ADDENDUM NO. 4:

RE: Town of Canton - Armory Community Center Renovation
71 Penland Street, Canton, NC 28716
CGD|PBK Project No. 23029

MAIN LEVEL NEW FLOOR
PLAN

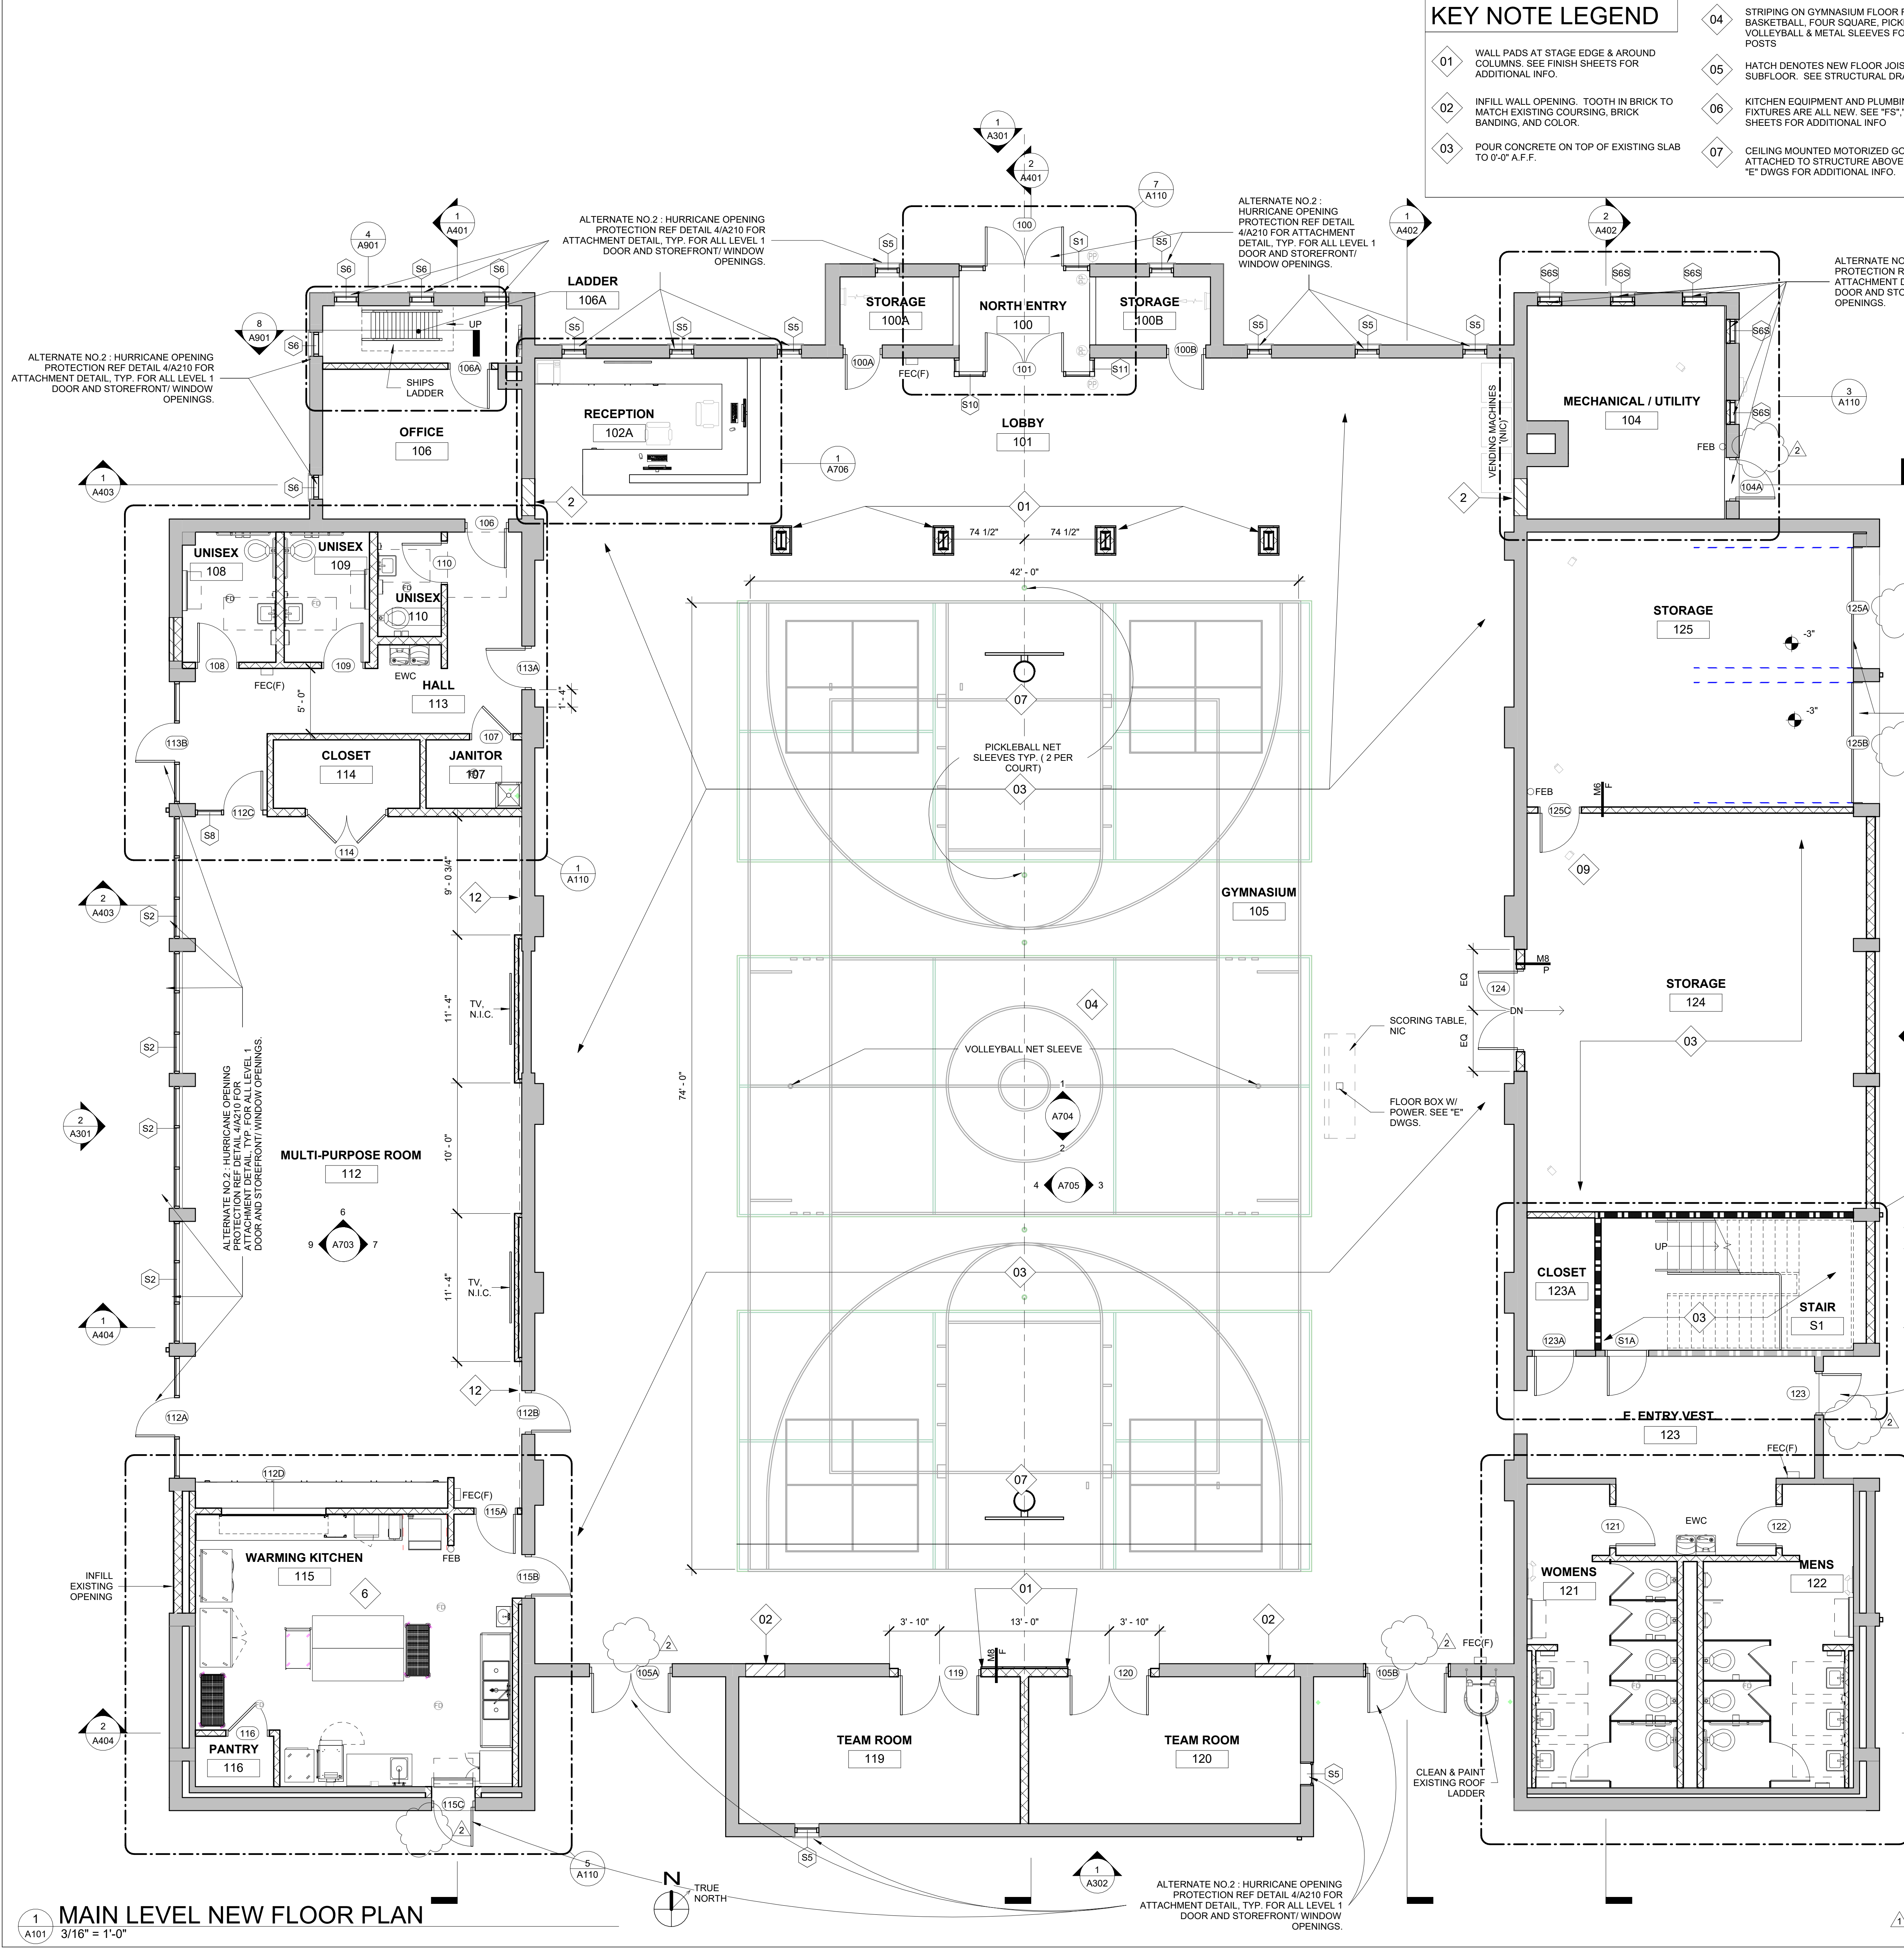
Question: Flood protection. What is the flood elevation height? Do they want a 4-sided seal covering the entire window and/or doors? Windows in rooms 104 and 106A do not show flood protection. Will flood protection be required on these as well?

A4-D1 **Drawing A101, MAIN LEVEL NEW FLOOR PLAN:**

REVISE: Keynote Legend. Keynote #13 is no longer used. All occurrences of Keynote #13 on the floor plan have been removed.

Answer: Flood Protection is not required on this project. Keynotes referring to this have been removed in the drawing revisions included in this Addendum.

1 UPPER LEVEL NEW FLOOR PLAN

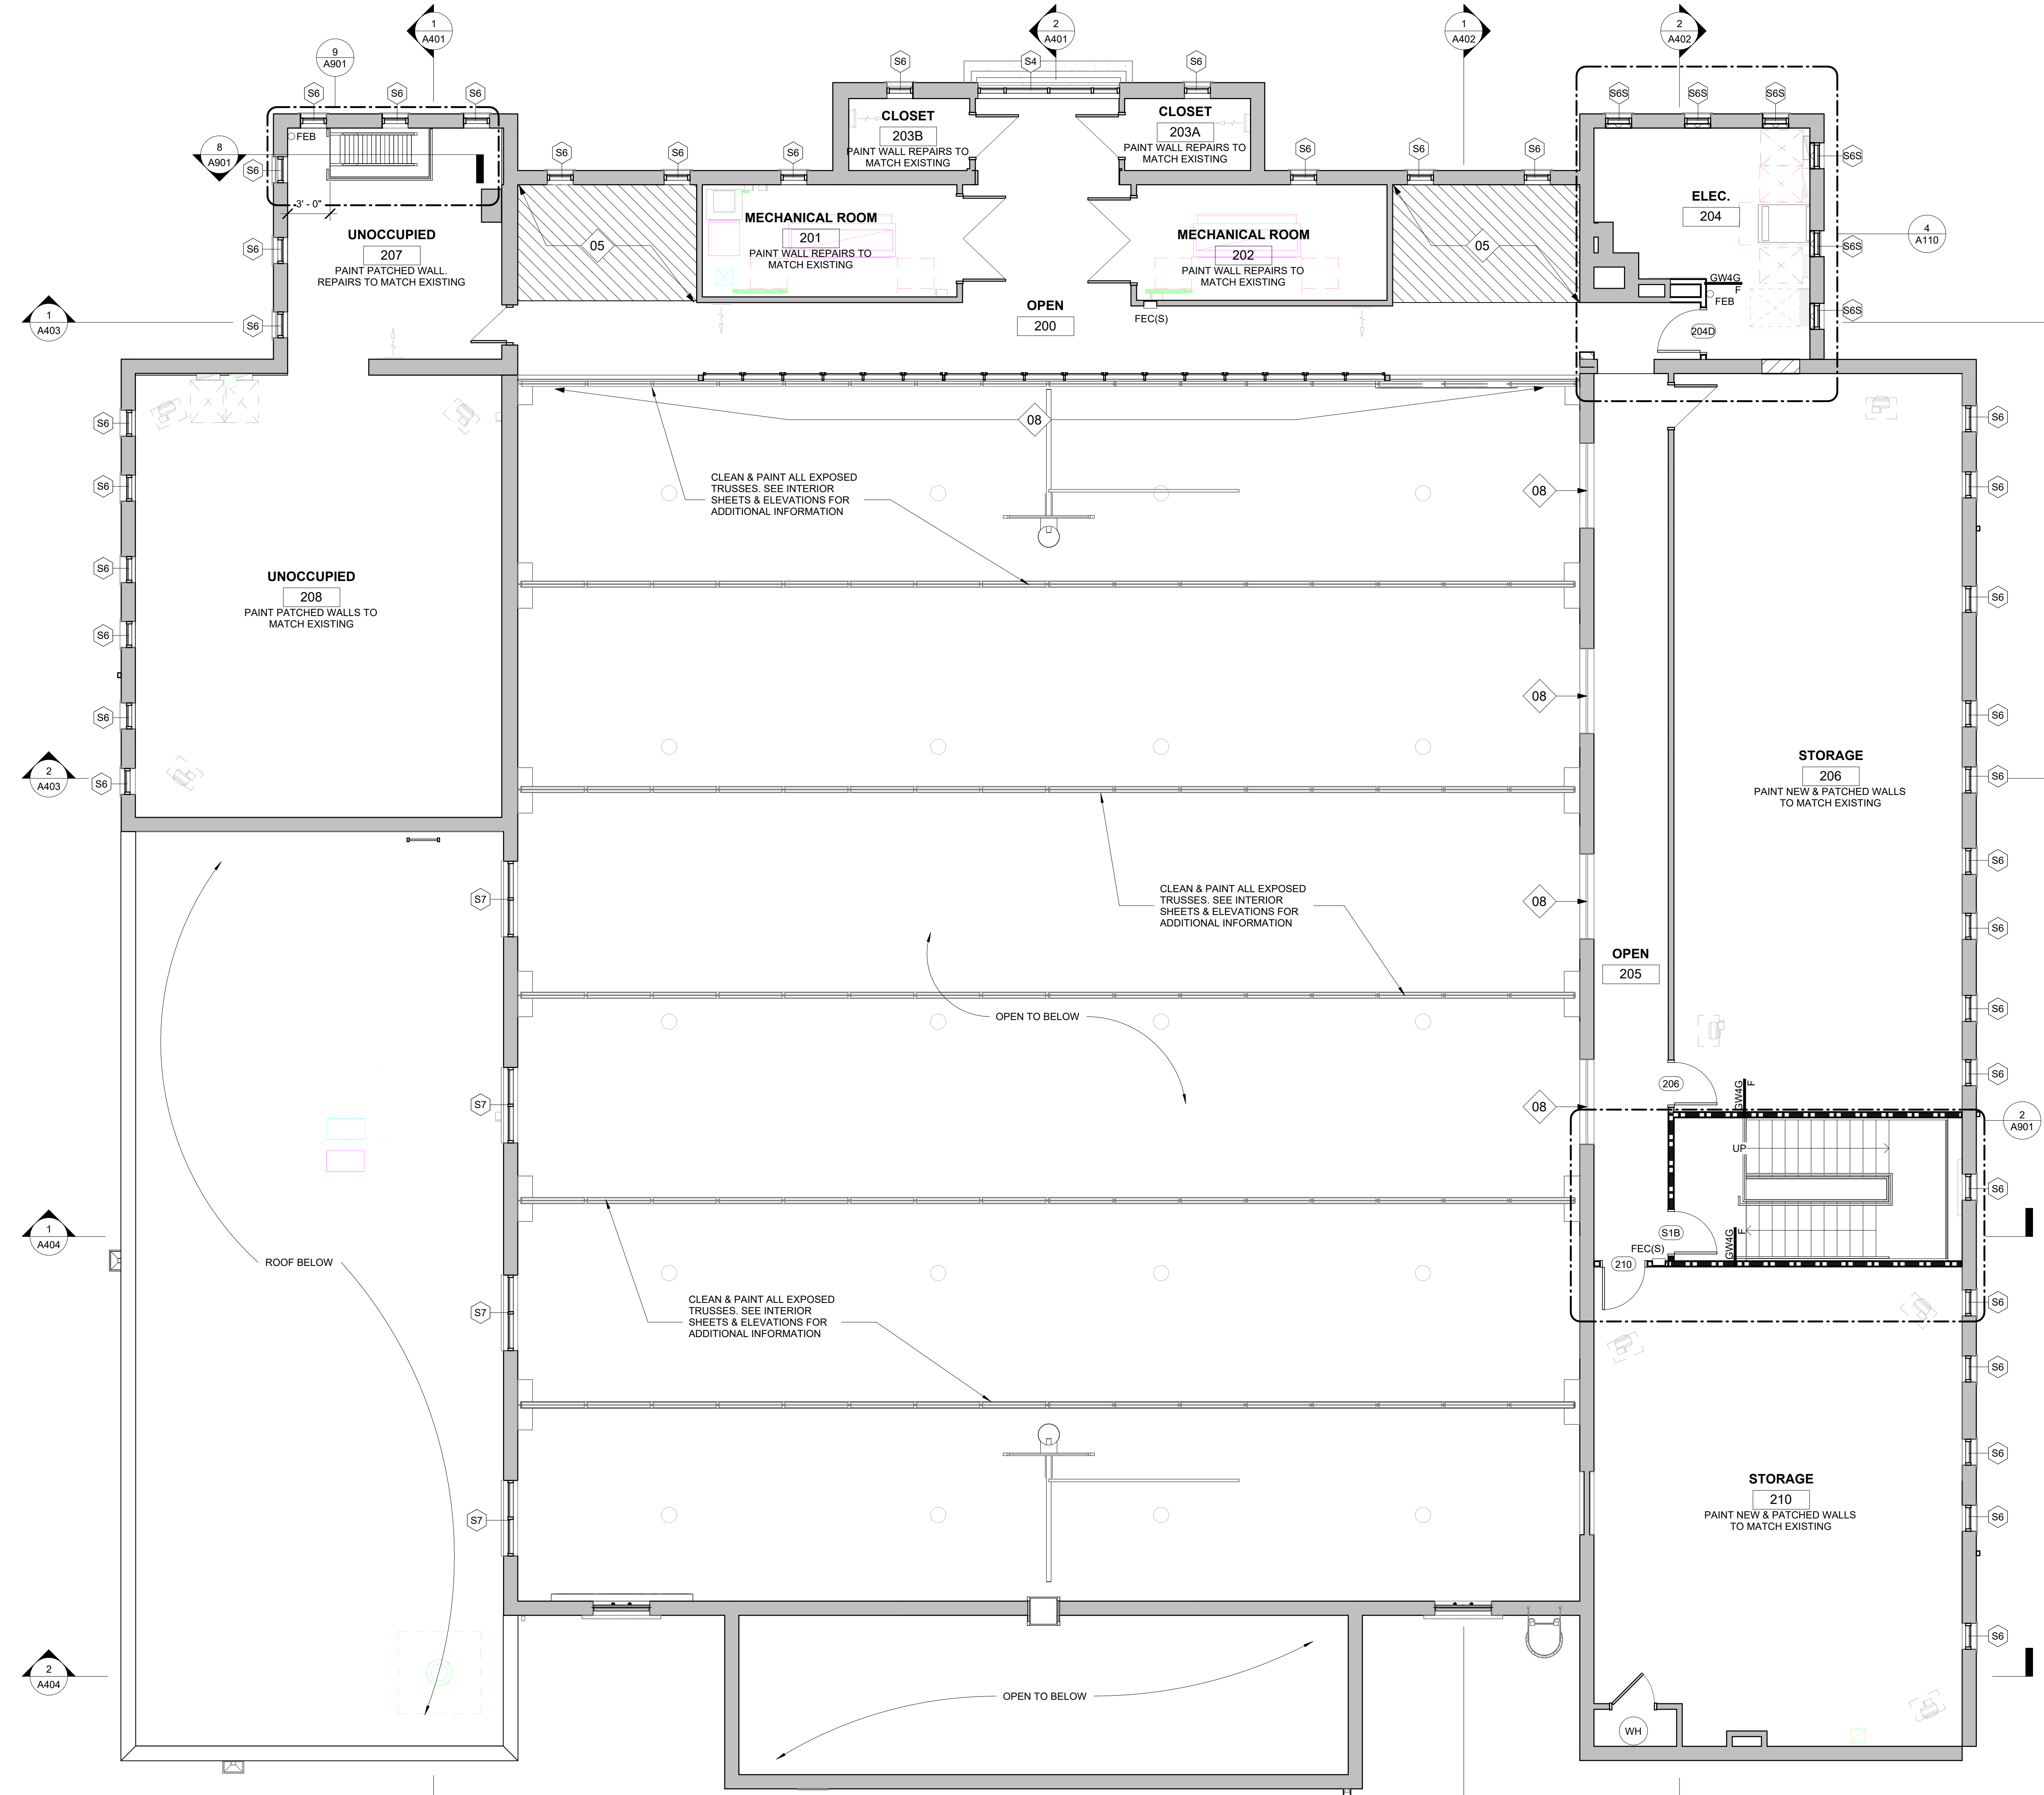
A4-D2 **Drawing A102, UPPER LEVEL NEW FLOOR PLAN:**

REVISE: Keynote Legend. Keynote #13 is no longer used.

MAIN LEVEL REFLECTED CEILING PLAN

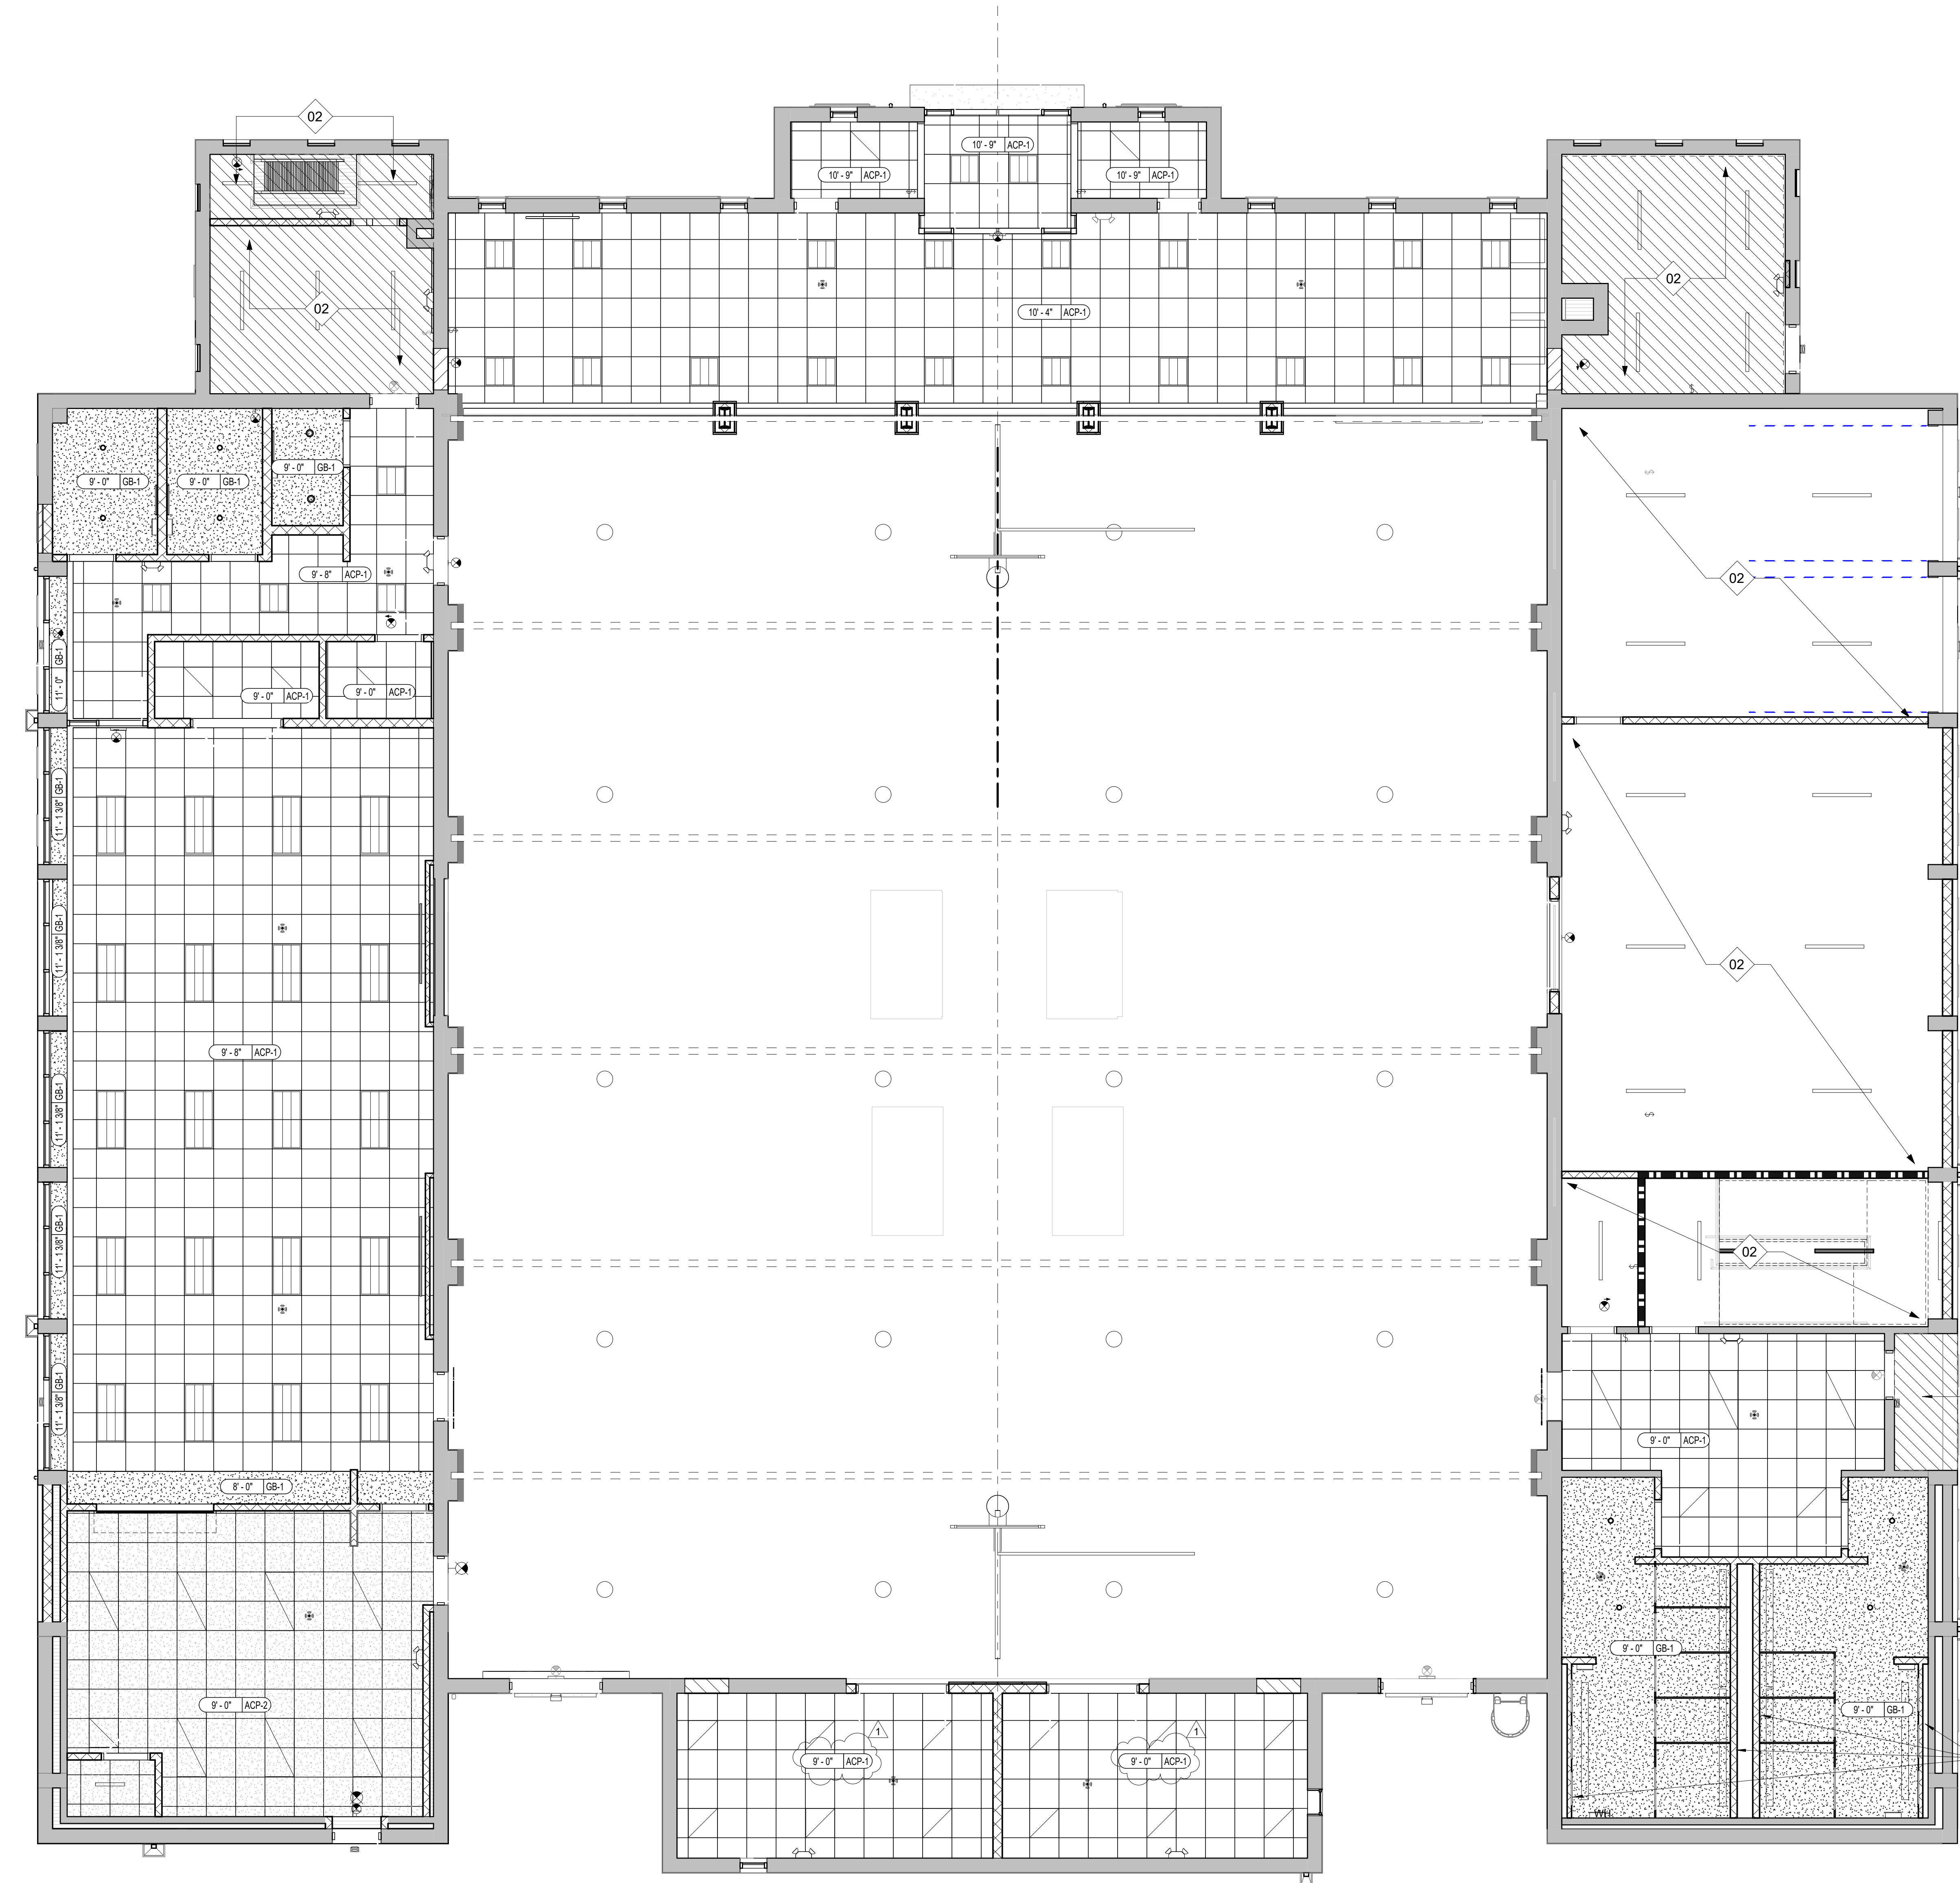
Question: A801 Shows ACP-1, ACP-2, and ACP-3. Legend in top right only shows ACP 1 & ACP-2 and it shows both as being 1" thick. Spec Section 09 51 00 only has ACP-1 and it does not match the legend information on the plans. Can you please clarify what will be required? Also, on the same page A801, does Keynote 01 apply anywhere as it does not match Alternate #2?

A4-D3 **Drawing A801, MAIN LEVEL REFLECTED CEILING PLAN:**

REVISE: Keynote Legend. Keynote #1 is no longer used. Keynote #4 was revised to coordinate with the roof plan. Revise reflected ceiling plan to indicate acoustic ceiling ACP-1 in Team Room 119 and Team Room 120. Revise RCP Legend, item ACP-1.

Answer: Specs and drawings have been updated to match.
